**Project Address:** 1206 Northport Drive  
**Application Type:** Demolition  
**Legistar File ID #** [31830](#)  
**Prepared By:** Heather Stouder, AICP, Planning Division  
 Report Includes Comments from other City Agencies, as noted

**Summary of Project Updates**

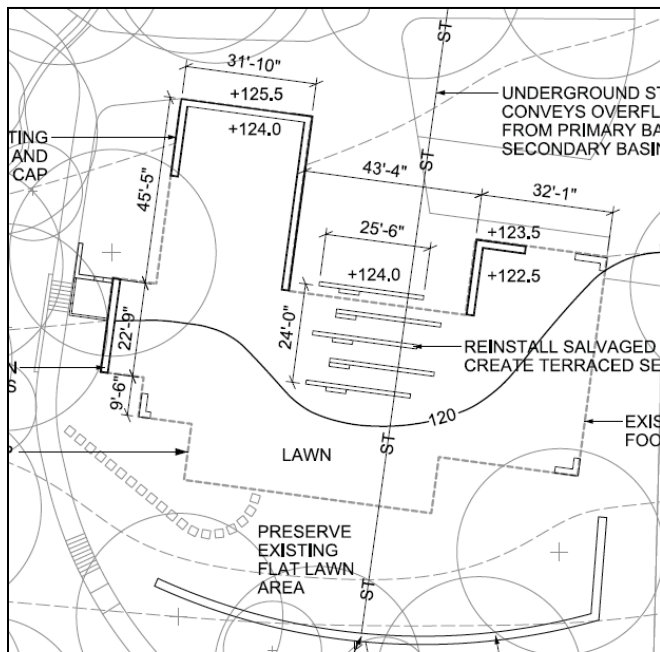
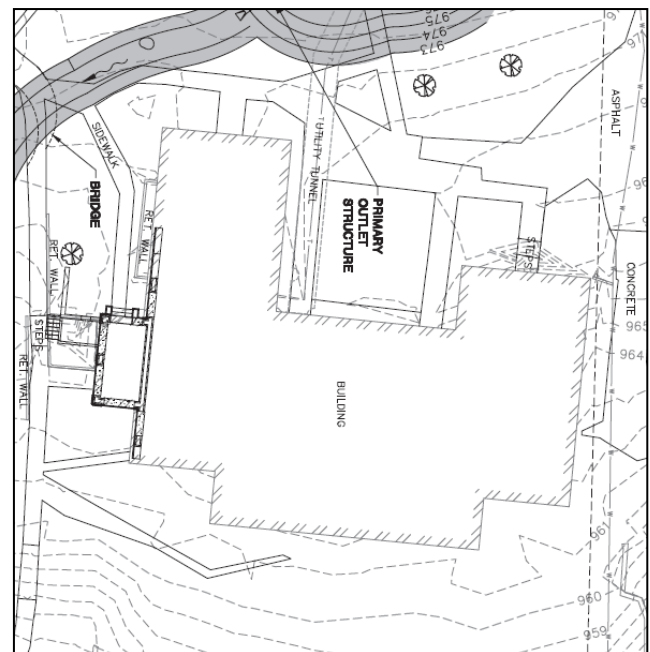
Since this proposal was referred by the Plan Commission in November, 2013, the applicant has met with interested neighbors on multiple occasions, and recently submitted revised plans for the site, which preserve a significant two-story element of the dormitory building. In 2013, the applicant proposed keeping low portions of the foundation outline of the building, and reinstalling some of the masonry as a seating area within the building footprint. In revised plans, the applicant proposes to maintain an approximately 170 square foot, 2-story element of the western portion of the building, along with an interpretive display of the building’s history. Other elements of the foundation and any new seating areas have been removed from the plans, as shown in the comparison below. The site will include interpretive signage explaining the extent and use of the Dormitory building, and will be accessible via a sidewalk from an accessible parking stall to the north.
